Product Change Notice (PCN)

PCN Number: PCN-0451086R-01

Product(s) Affected: PJ-038-SMT and PJ-039-SMT

PJ-038-SMT

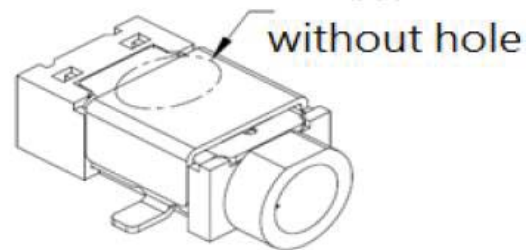
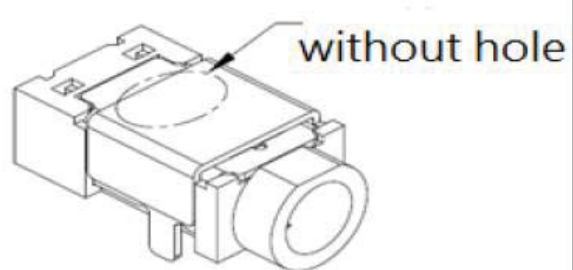
Description of Change: appearance change as shown below:
